# Product Change Notification

## 112069 - 00

<b>Change Notification #:</b>	<b>112069 - 00</b>
<b>Change Title:</b>	<b>Intel® PRO/1000 PF Dual Port Server Adapter (Bretona) OEM Gen EXPI9402PFG2P20 MM# 882458 &amp; Retail SKUs EXPI9402PF MM#868974 &amp; EXPI9402PFBLK MM#886975 and Intel® PRO/1000 PT Dual Port Server Adapter (Redwater) OEM Gen SKUs EXPI9402PTG2L20 MM#882886 &amp; EXPI9402PTG2P20 MM#882028 &amp; Retail SKUs EXPI9402PT MM#868973 and EXPI9402PTBLK MM#868971</b>  <b>PCN 112069-00</b>  <b>Documentation, Label</b>  <b>ROHS Flyer, Remove CDA (EXPI9402PF, EXPI9402PFBLK, EXPI9402PT, EXPI9402PTBLK) and Update Labels</b>
<b>Date of Publication:</b>	<b>March 01, 2013</b>

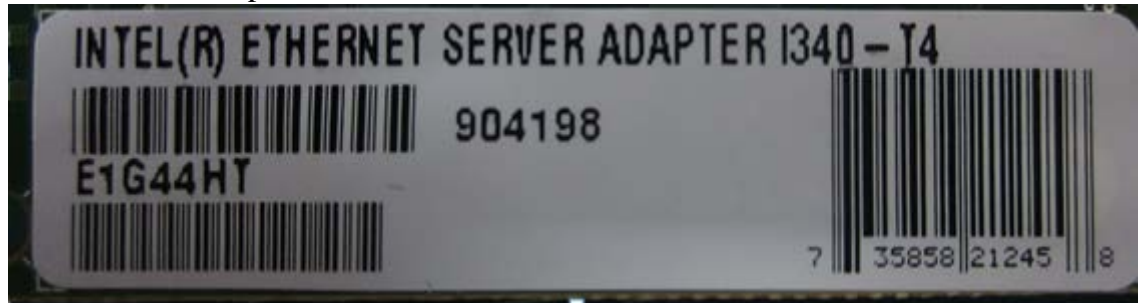
### 3. Distribution Label Change

Intel Corp is standardizing packaging label formats across the corporation. This will facilitate easier receiving for the end customer.

Intel will begin implementation of UPC and EAN (European Article Number) codes on the product outer case labels.

A new line of text will be added that states either:

- Product is individually labeled for resale.
- Product is not individually labeled for resale.

Additional fields are being added to display the outer case UPC and EAN codes for overall carton quantity. New UPC codes for individual boxes are also being added.

2D matrix label will be added for easier product information scanning.

Customers should be aware that UPC and EAN codes on the outer case carton labels will be changed and that they may need to update their incoming receiving operations. Customers may receive both current and new inventory as the implementation occurs.
